MIL-R-83536/8
AMENDMENT 1
15 December 1995

MILITARY SPECIFICATION SHEET

RELAYS, ELECTROMAGNETIC, ESTABLISHED RELIABILITY, 4PDT, LOW LEVEL TO 5 AMPERES, PERMANENT MAGNET DRIVE, MAGNETIC LATCH, HERMETICALLY SEALED, ALL WELDED, TRANSIENT SUPPRESSED DC COILS

This amendment forms a part of MIL-R-83536/8, dated 27 March 1992, and is approved for use by all Departments and Agencies of the Department of Defense

CIRCUIT DIAGRAM
(OPTIONAL INTERNAL DIODE CONFIGURATION)

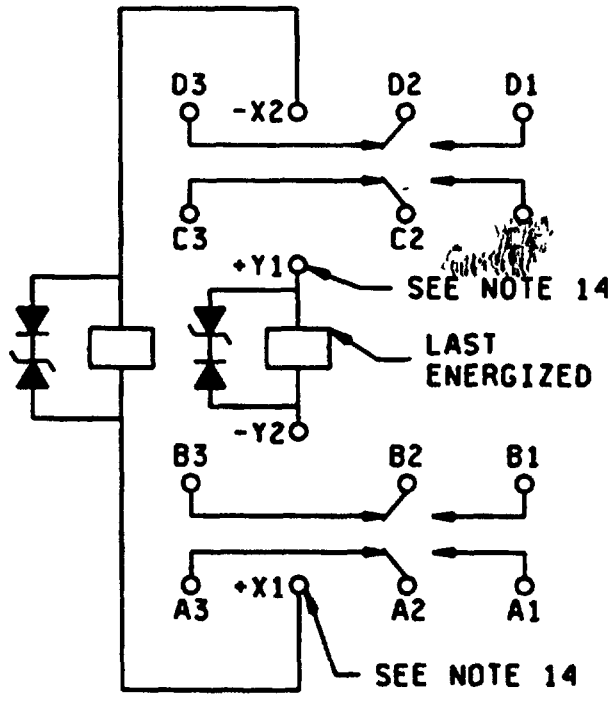
FIGURE 1, add the following circuit diagram
